**REZONING MASTER PLAN**

**HUNNICUT & MASON**

## STAFF REPORT

**REQUEST:** Master Plan Revision for a property zoned CPDP/Combined Planned Development Project (Single-Family) and (Multifamily)

**SHEET 1**

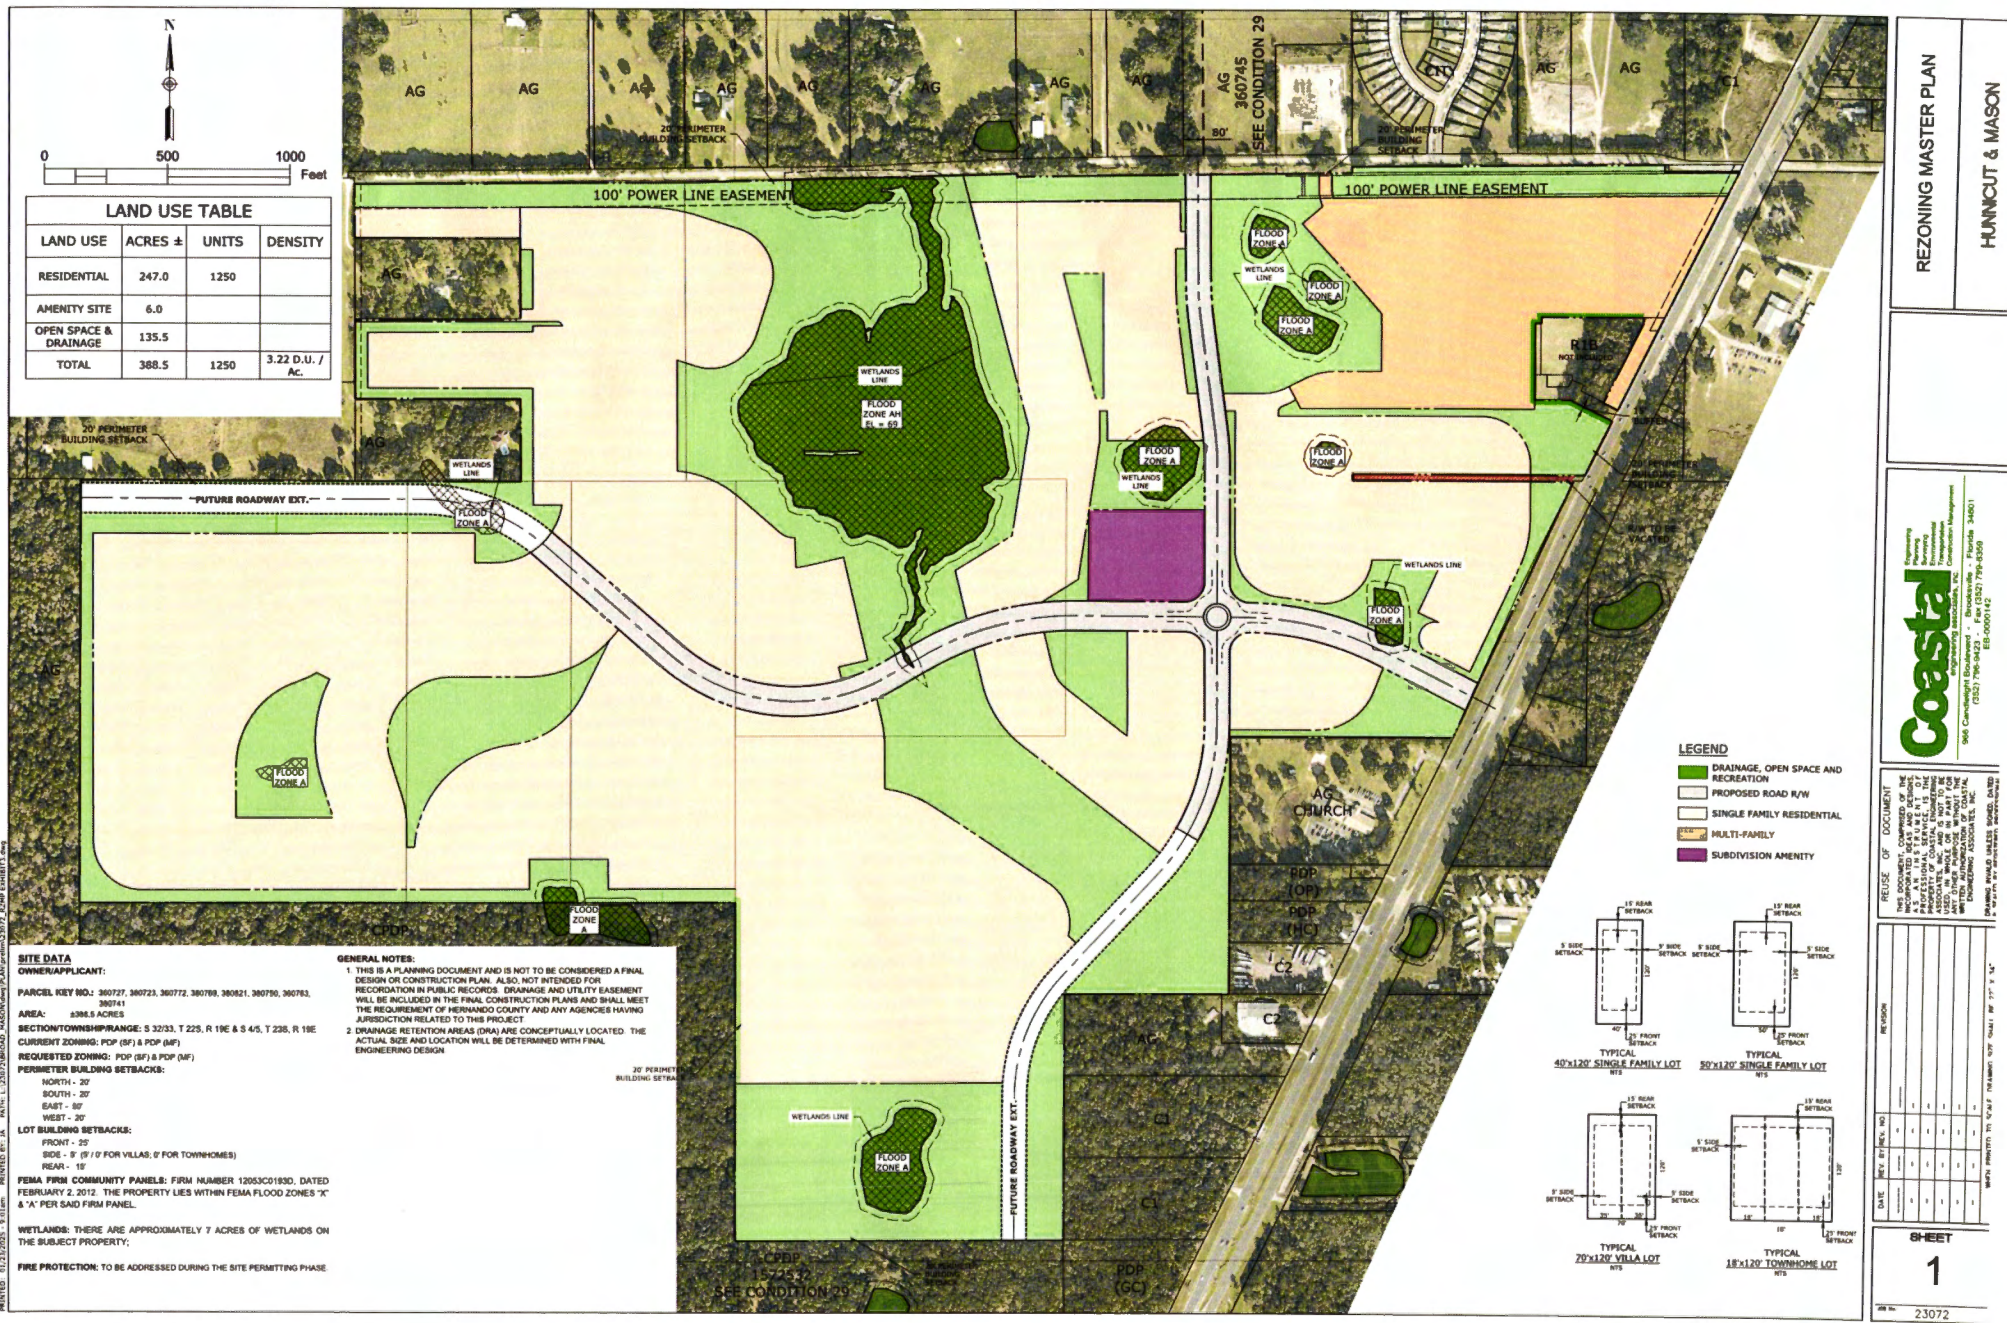
12. A FDOT access management permit is required for access to US Hwy 41 (Broad Street).
13. The petitioner shall construct a north/south collector road to County standards from Mason Smith Road to the South as depicted on the Master Plan, within the PDP Boundary; southern property boundary. approximately 800' from the intersecting roundabout with the east /west collector road. ~~This road shall be constructed in its entirety at the time the pod utilizing this collector road is~~

~~constructed and shall be required in lieu of a frontage road. A connection of the north/south collector roadway to the southern boundary will be made within 1 year of when based upon need and demand by the County Engineer.~~ a physical connection can be made to the southern parcel (Hernando Oaks Phase 5) roadway, provided that such roadway has been constructed prior to the last record plat within the Hunnicutt Mason PDP. A roundabout shall be constructed at the intersection of the north/south collector road and the east/west collector road when a functional connection is made between the two pods.

14. The petitioner shall construct an east/west collector road to County standards from ~~Mason Smith Road~~ US Hwy 41 (Broad Street) to its intersection with and the north/south collector road to the western property line for a future connection. The physical connection to the western property line shall be made within 1 year of when a physical connection can be made to the Western property (Parcel 380803 or Parcel 1077756) internal roadway, provided that such roadway has been constructed prior to the last record plat within the Hunnicutt Mason PDP. based upon the need and demand as determined by the County Engineer.

22. The petitioner shall be required to provide a total of 6 acres of dedicated neighborhood park space (~~3 per residential pod~~) for the subject development. The primary park shall be located at approximate to the center of the sites, along the ~~East/West north/south~~ collector road. Additional pocket parks recreation space will be provided as passive as recreation shall be located in various places throughout the development to allow access to recreational amenities. All neighborhood parks shall be accessible through pedestrian, bicycle and vehicular means.

29. The developer must demonstrate and design the proposed North/South collector road to align with the planned roadway improvements at its north and south boundaries. The northern connection at Mason-Smith Road would align with the western 80 feet of Parcel Key # 360745 and the southern connection would be in proximity to the eastern boundary of Parcel Key #1572532. The alignments for these proposed connections shall be reviewed and approved by the Hernando County Engineer.
